STATE OF ALASKA  
DEPARTMENT OF PUBLIC WORKS  
**DIVISION OF WATER & HARBORS**

KNUDSON COVE FLOAT FACILITIES  
PROJECT NO. 5-68117  
KETCHIKAN CITY FLOAT FACILITIES  
PROJECT NO. 3-68142

AS BUILT

**KNUDSON COVE PLAN LAYOUT**  
Scale 1" = 50'

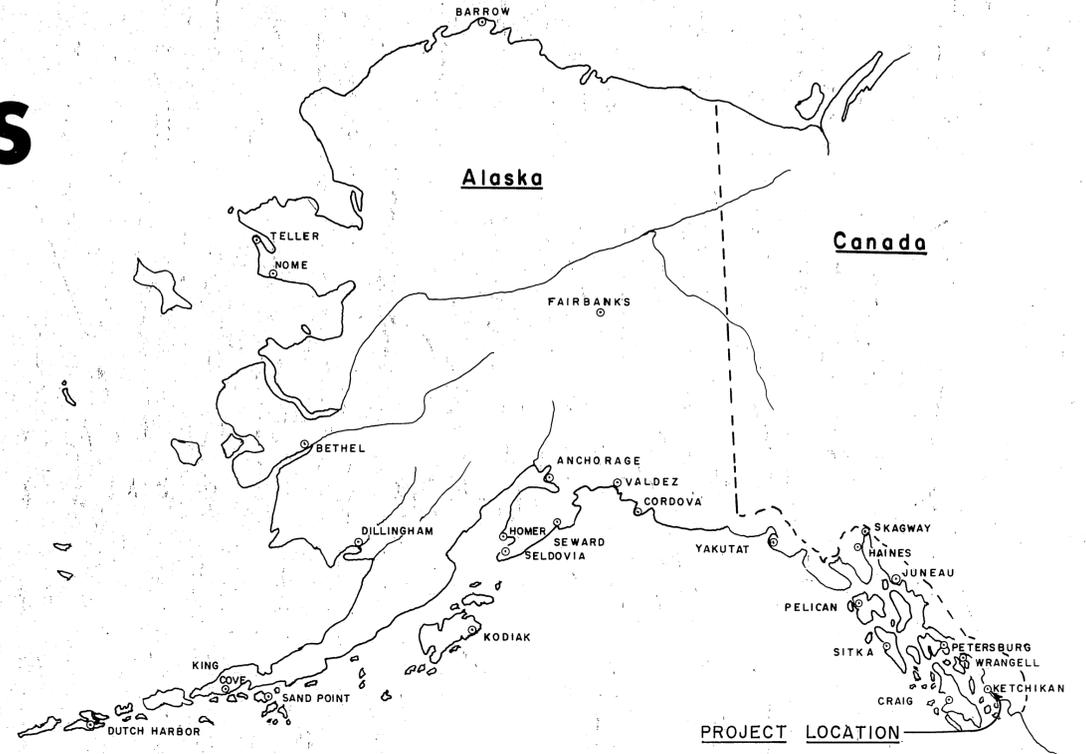
Floata not constructed per plans, mostly due to improper fabrication. 6" shortage on bullrails-pontoon sections pulled together to make up the difference, see sheet 3

Knudson Cove Proposed Dredging Layout  
Scale 1" to 20'

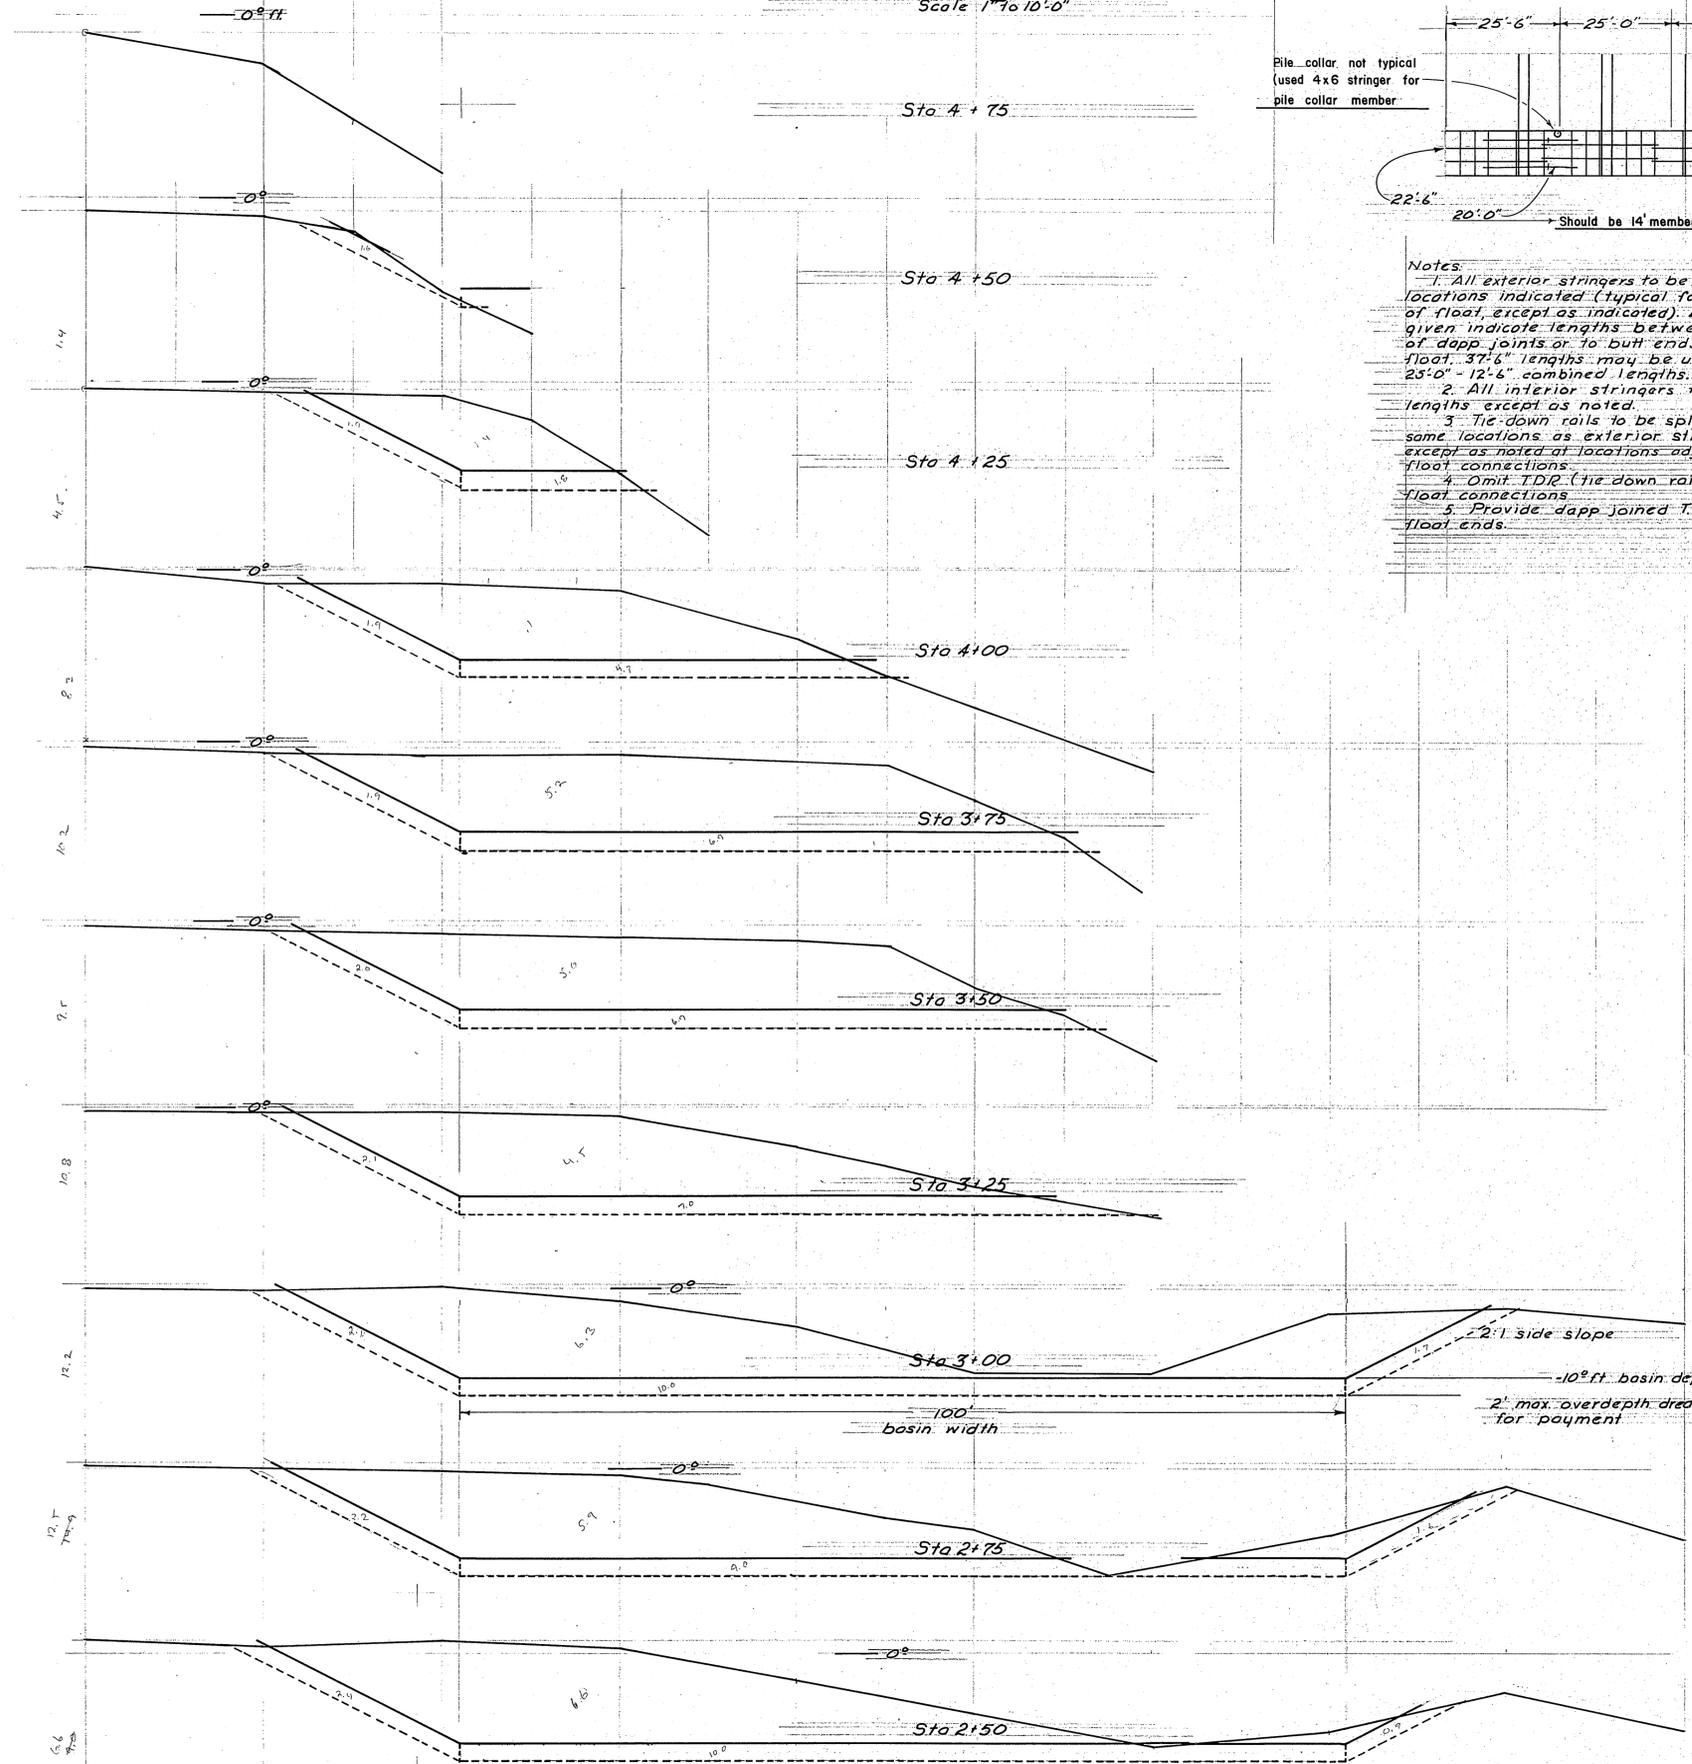
Due to the small amounts of irregular portions of overdepth remaining & considering the contractor's diligence in removing the dredged material under the difficult conditions encountered - it was decided to pay the contractor for the total estimated yardage (5000) as set forth in the bid schedule.

**Stringer & Tie-down Rail Layout Diagram**  
Scale 1" = 20'-0"

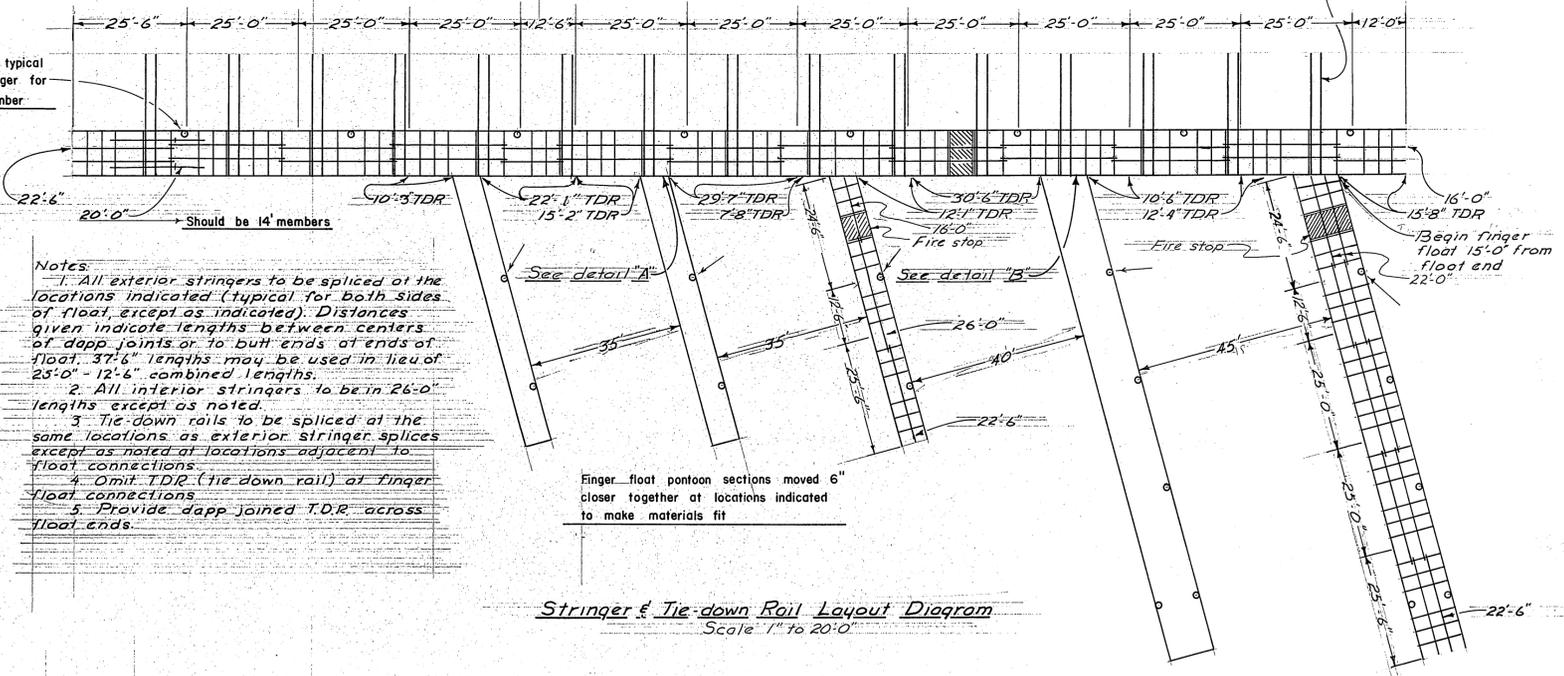
Pile collar not typical (used 4x6 stringer for pile collar member)

Knudson Cove Proposed Dredging Layout  
 Scale 1" to 20'

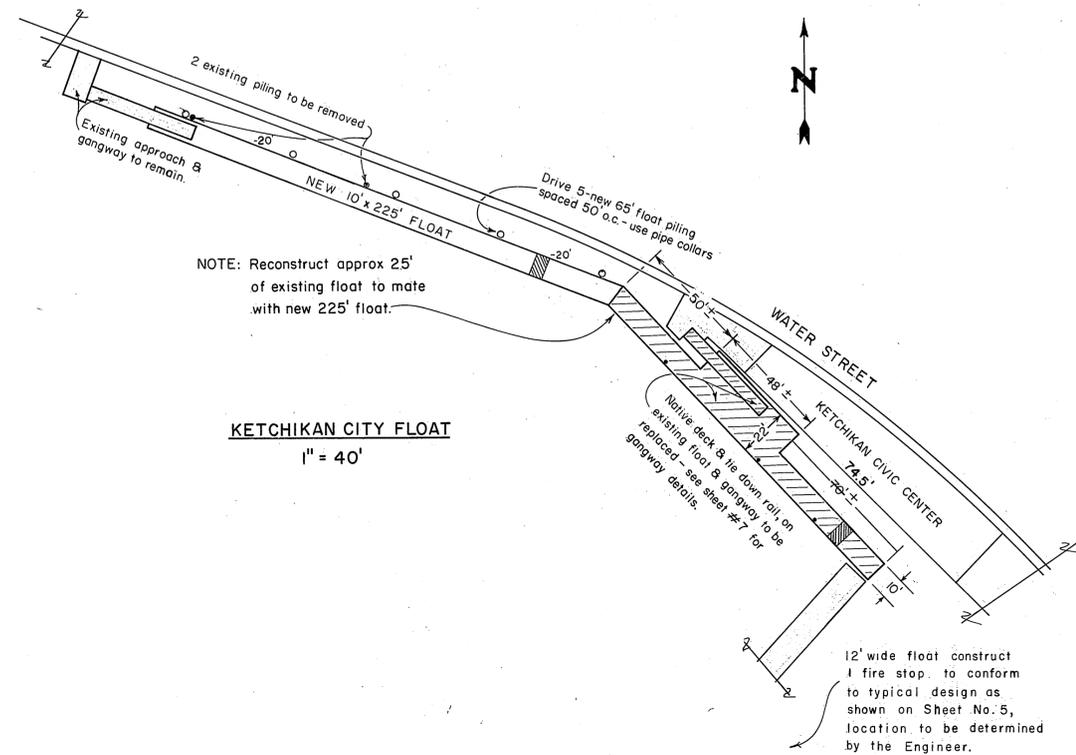
note: As-Built DWS used  
 22" DECK ELEVATION AT  
 MAIN OR NEW CONTROL -  
 SHOULD HAVE BEEN 25"  
 - DEDUCT 2" FROM ALL DEPTHS  
 SHOWN
